Subject:- Construction of Health Wellness Centre (HWC - SHC) without labor room and
without residence at various village in the State of Haryana.

Memo No. Arch-2024/SA-III/ 11258 - 60
Dated, Chandigarh the 08/11/24

Subject: - Construction of Health Wellness Centre (HWC - SHC) without labor room and without residence at various village in the State of Haryana.

STANDARD HEALTH WELLNESS
CENTRE DESIGN-I WITHOUT LABOUR
ROOM AND RESIDENCES

GROUND FLOOR PLAN,
ELEVATIONS & SECTION

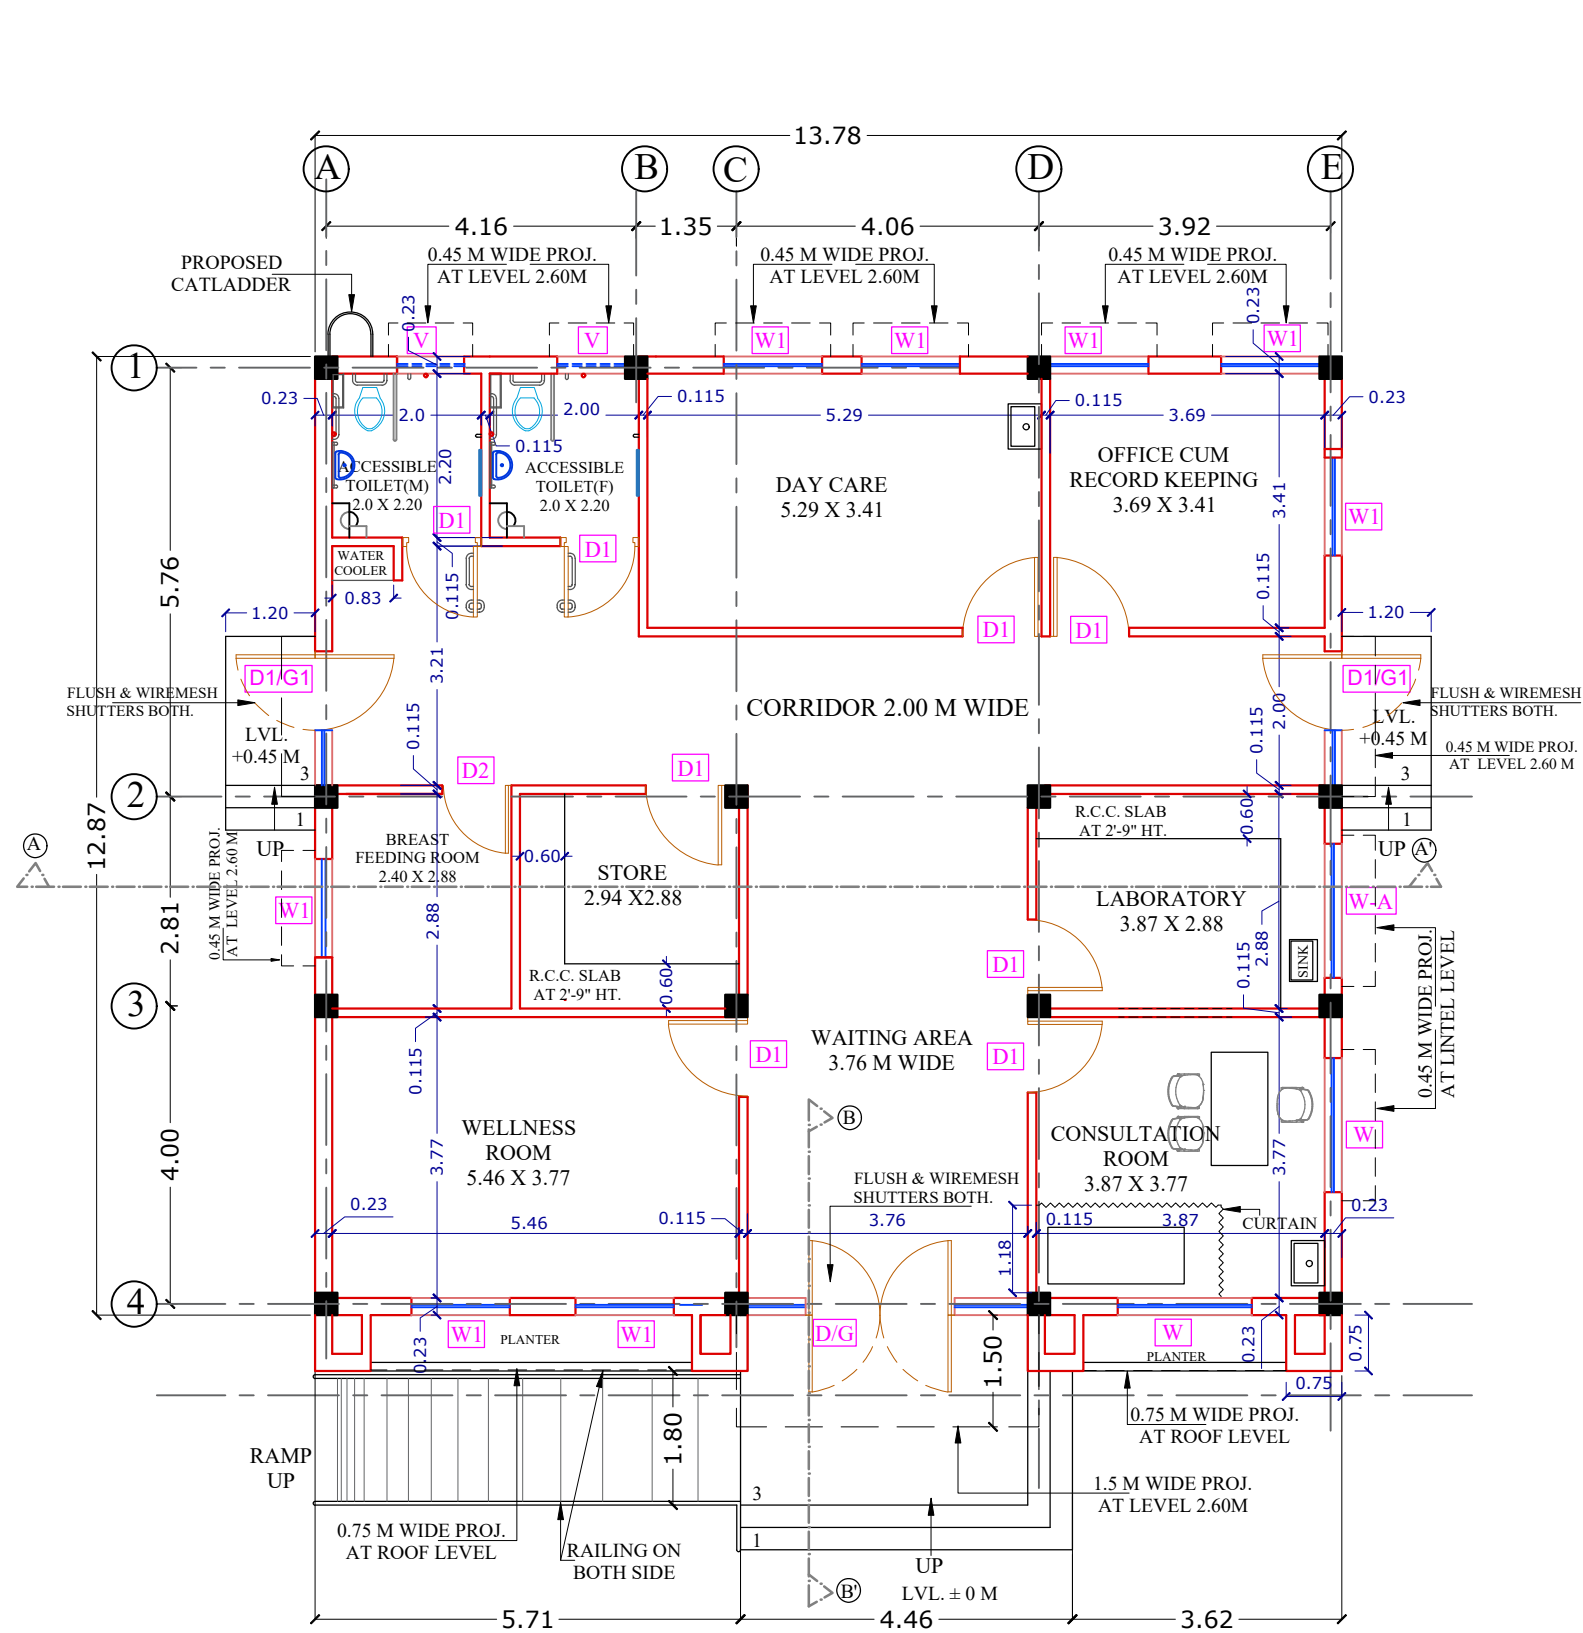
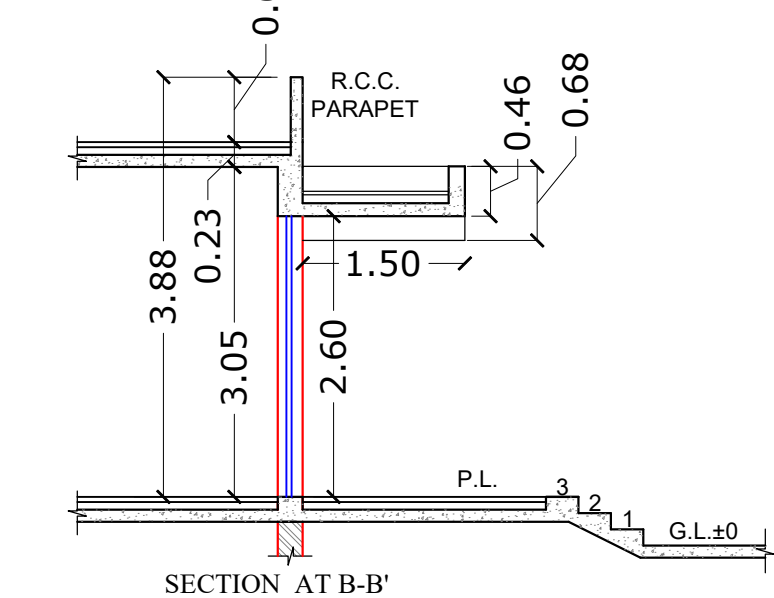
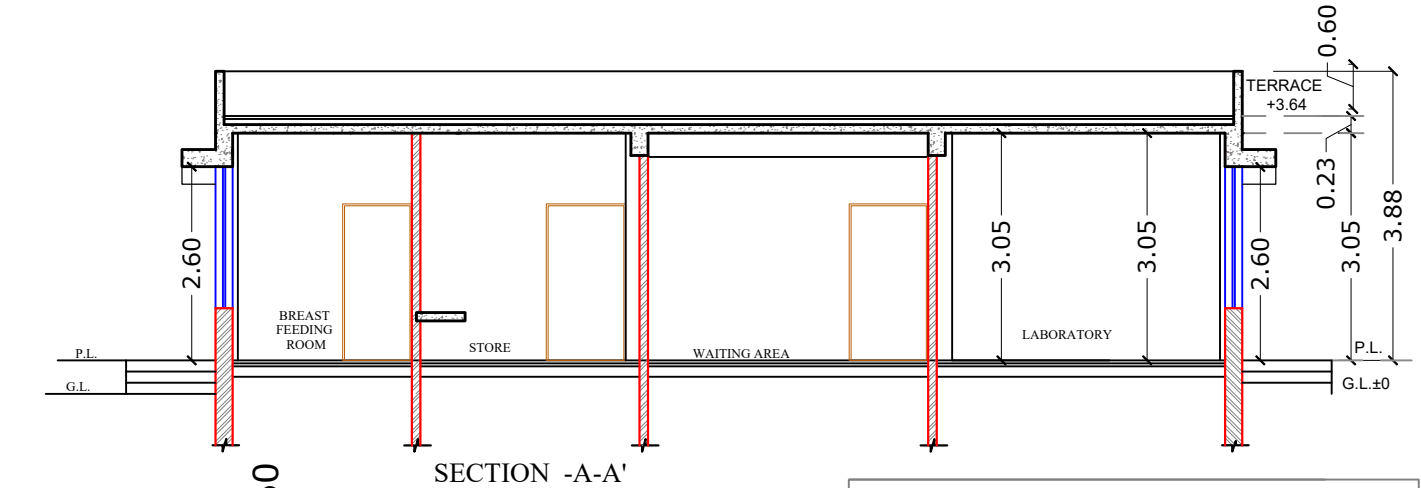
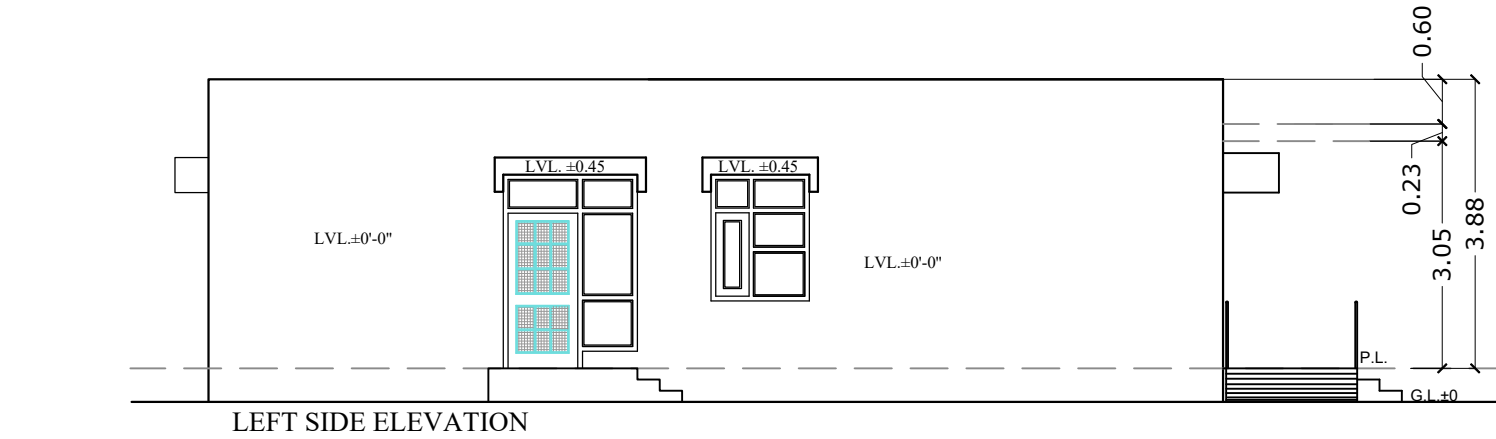
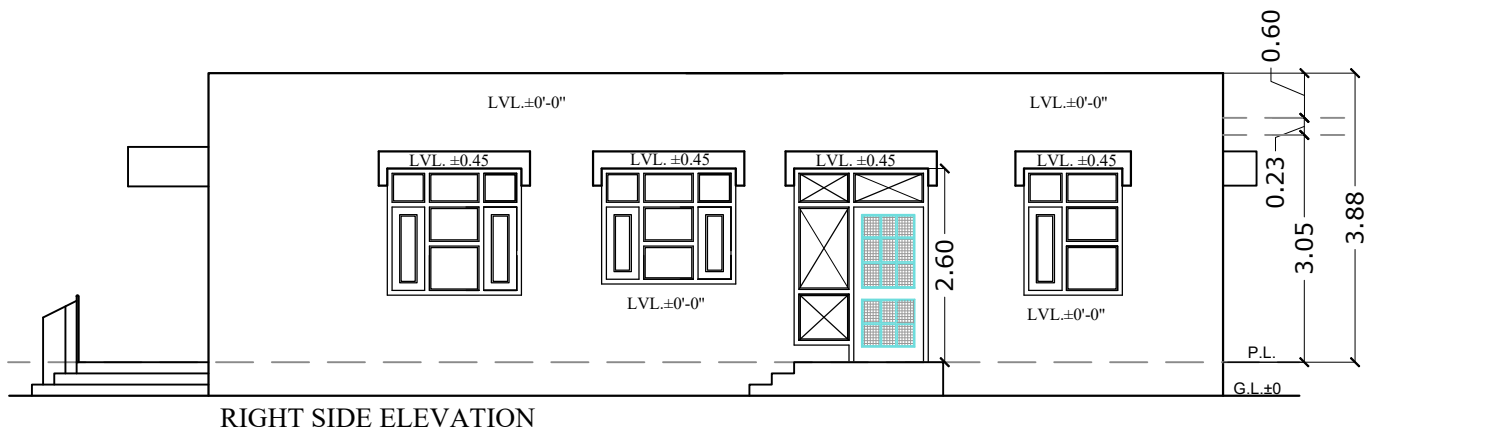
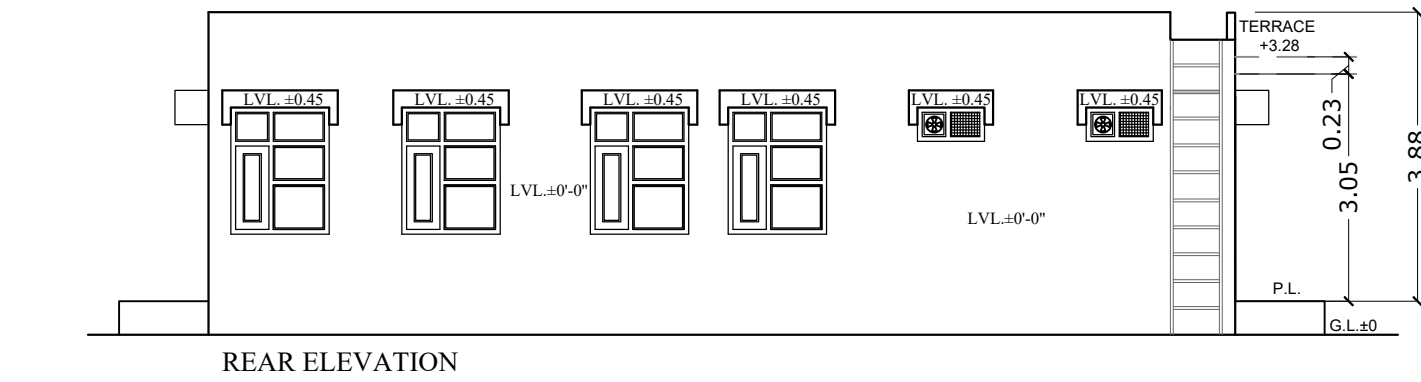
- The sizes of columns and beams as shown in the new standard design of HWC-SHC building having a covered area of 187.60 sq.mtr. bearing Drg. No. 1C of Job No. 3152 have been kept

same as of the original standard design having a covered area of 212.70 Sq.mtr. bearing Drg. No. 3R-1 of Job no. HWC and the same may be followed as per the revised structural advice. However, the location of columns and beams have been changed due to change in the size of few rooms to reduce the covered area of HWC-SHC building. Accordingly, the revised structural advice as per the new design of HWC-SHC building bearing Drg. No 1C of Job No. 3152 shall be taken prior to start of construction. The steel reinforcement in the columns, beams, lintels and roof slabs shall be designed and provided as per the requirement of seismic/ earthquake zone in which the proposed site falls. The foundation of the proposed HWC-SHC building shall be designed separately for each site according to the type of soil exists at different sites. Further, any requirement of drawings, if any, may be communicated to this office.

- The main entry side facade of the proposed SHC building has slightly been modified by providing joinery upto the height of 8'-6", projection over main entrance has been provided at 8'-6" height to enhance the appearance of the HWC-SHC building. The floor to ceiling height has also been reduced from 3.41 mtr. to 3.05 mtr.

- IT IS INTIMATED THAT VIDE MINUTES OF MEETING DATED 10-10-2024, DGHS HARYANA OFFICE HAS REQUESTED TO REVISE THE EARLIER APPROVED STANDARD DESIGN OF HEALTH WELLNESS CENTRE (HWC-SHC) HAVING A COVERED AREA OF 212 SQ.MTR TO 192 SQ.MTR TO REDUCE THE ESTIMATED COST OF CONSTRUCTION SO THAT HWC-SHC AT VARIOUS VILLAGES CAN BE CONSTRUCTED WITHIN THE BUDGET APPROVED UNDER 15TH FINANCE COMMISSION.

- ACCORDINGLY, AS PER YOUR REQUEST, THE EARLIER APPROVED DESIGN OF HWC-SHC HAS BEEN REVISED BY REDUCING THE SIZES OF FEW ROOMS AS PER THE DISCUSSIONS HELD WITH THE DEPUTY DIRECTOR (CONSTRUCTION) O/O THE DGHS HARYANA AND CHIEF ENGINEER, PANCHAYATI RAJ, HARYANA DURING THEIR VISIT TO THIS OFFICE ON DATED 10.10.2024. THE COVERED AREA OF THE HWC-SHC HAS BEEN REDUCED TO 187.60 SQ.MTR.
